Technical Report 627

CABLE FAILURES IN THE AN/BQS-15 SONAR SYSTEM

Anal, sis of failures in the depression/elevation drive-motor power cable and recommendations for their prevention

June 1980

Figure 16. Proposed change for connector P2 of cable W 31,

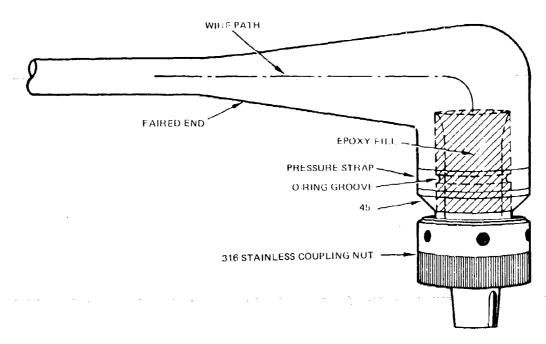
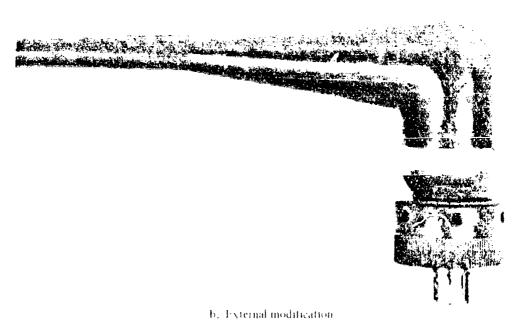
The material used for a water block in the system should not extend into the stress relief portion of the mold but should be terminated at the end of the metal sleeve. Additionally, the stress relief portion of the mold should be faired into the cable rather than terminate as a step at the cable end. The cutout portion of the smaller MIL-C-24217/3-001 connector should be eliminated, the lines routed up and over the metal sleeve, and the mold changed to accommodate this in a manner similar to that of MIL-C-24231/2-001. A sketch showing this can be seen in figure 16. It illustrates the 90° termination, the fairing into the cable, routing of the wires around the rear of the metal sleeve, the epoxy water block, a metal pressure strap, and an O-ring groove in the metal sleeve directly under the metal strap. The metal strap is recommended since there have been laboratory results (at NUSC) showing that its use apparently aids in the tolerance of the bond to a severe pressure environment. Some results using the strap have shown bond failure in all areas except directly below the metal strap. Installation of the metal strap can be simple. One method would be to tighten the strap so that the exposed surface of the strap just becomes flush with the exterior surface of the neoprene. A buckle would be used to tie the strap in a manner presently used on many deep-submersible transducers. A specially designed tool has been fabricated for this purpose; details of the tool are available from NOSC.

A proposed solution to the problem was presented for comments This solution is illustrated below along with the existing connector.

A principal fault with the existing 90° connector emanates from the laying up of the epoxy water block. The volume encapsulated in the conical strain section has several problems related to it:

- 1. It reduces the minimum neoprene bond water path from an available 3/8 inch to 1/4 inch.
- 2. It does not allow the strain relief section to function as designed.
- 3. It is not layed up uniformly.
- 4. All dissected pieces showed cracking of the water block closest to the connector metal sleeve near the wire entry notch.

Figure 1.

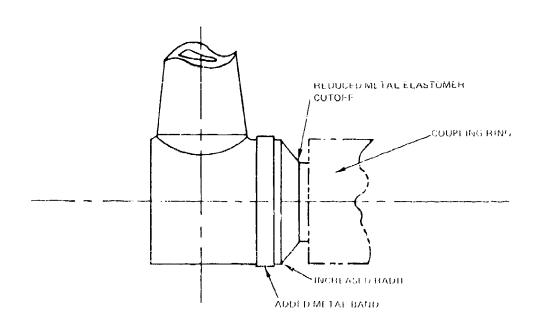
- 7. Some other changes to improve the product might be considered.
- a. Add a test for integrity of the bond, such as a pry test, to the specification for this connector (MIL-C-24217 (SHIPS)). This would be a 100% test requirement.
- b. Add a peel test to paragraph 3 on a sample basis to prove out production process.
 - c. Changes to design.
- (1) Bonding of metal to rubber can be greatly improved and life expectancy extended for a much longer period if the leading edges of the bond area are kept in compression. This may be accomplished by placing a strap around strain relief. See Figure 1.
- (2) Bond design. The elastomer shape should avoid any sharp radii and abrupt elastomer-metal cutoff. The present design has both discrepancies and the shape could be changed as shown in Figure 1.

Figure 2.

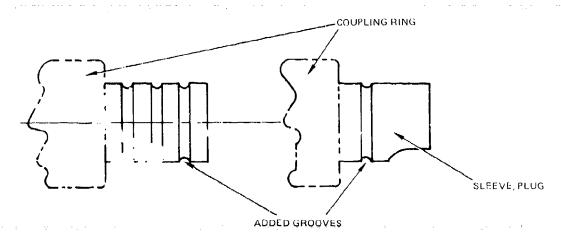
(3) The effective bond length may be increased and an C-ring type action obtained by cutting grooves on the metal part. (See Figure 2.) This also gives more mechanical strength.

Figure 1. Polyurethane encapsulated MIT C 24217 right angle connector.

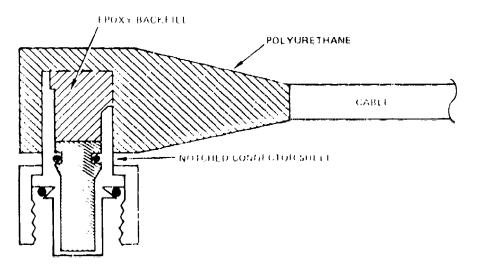
- 3. We concur with the failure analysis findings that the AN/BOS-15 cable connector assemblies flooded at the cable connector. Suggest that two alternative methods be considered. The methods are to encapsulate connectors with polyurethane, enclosure (1), fig 1, or to manufacture the proposed right angle connector cable assemblies incorporating a straight inline connector shell, detailed in enclosure (1) of reference (a).

- 4. Polyurethane encapsulated connectors have proven to be reliable for deep submergence service. The uniformally molded polyurethane encapsulation eliminates the stress fracture failure at the strain relief area and increases the available bond surface from 0.25 inches to 0.375 inches, enclosure (1), fig 1. The polyurethane to metal interface can be visually inspected for bond integrity without the use of prying tools, which could damage bond integrity. The

Throne 2. D'A molded right angle connector,

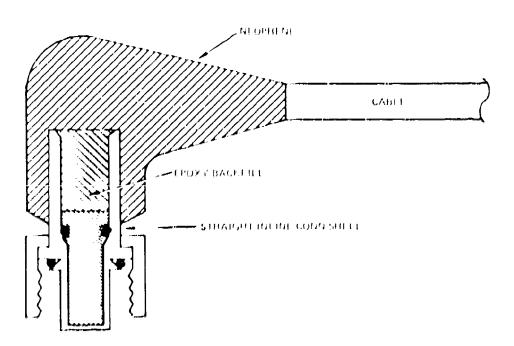
- 5. Right angle connector assemblies similar to the proposed method detailed—in enclosure (1) of reference (a) has been in service on the DSV's NR-1 and DSRV's with satisfactory results. See fig 2 of enclosure (1). The connector assemblies are repeatedly subjected to 6.5k foot depths without significant failures. The connector assemblies installed on the NR-1 and DSRV's do not incorporate pressure bond straps and in service data is not available. The proposed encapsulation method has more available connector bonding surface than the MIL-C-24217 right angle connector, and eliminates the stress fracture failure at the cable strain relief area. The proposed connector assemblies can be installed in areas where vertical clearance is not critical.
